# Mobile Intel® Celeron® Processor on .13 Micron Process in Micro-FCPGA Package

Specification Update

*September 2003*

Document Number: 251309-015

**Figure 12. System Bus Reset and Configuration Timings**

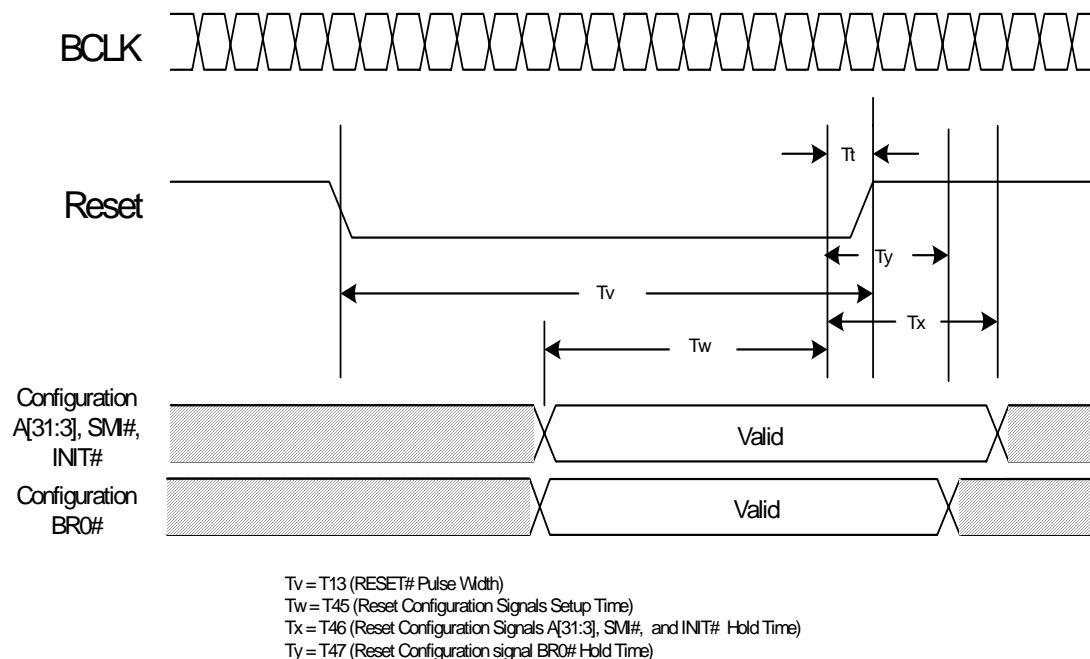
## V2. BR0# Maximum Hold Time Specification Change

The BR0# maximum hold time has changed to 2 BCLKs. This change will be shown in the “System Bus AC Specifications (Reset Conditions)” table and “System Bus Reset and Configuration Timings” figure of the *Mobile Intel® Celeron® Processor on .13 Micron Process in Micro-FCPGA Package Datasheet*. This change will be incorporated in the next revision of the datasheet.

The following figure will be modified to reflect this change:

T# Parameter	Min	Max	Unit	Figure	Notes
T45: Reset Configuration Signals (A[31:3]#, BR0# INIT#, SMI#) Setup Time	4		BCLKs	13	1
T46: Reset Configuration Signals (A[31:3]#, INIT#, SMI#) Hold Time	2	20	BCLKs	13	2
T47: Reset Configuration Signal BR0# Hold Time	2	2	BCLKs	13	2

1. Before the deassertion of RESET#.
2. After clock that deasserts RESET#.
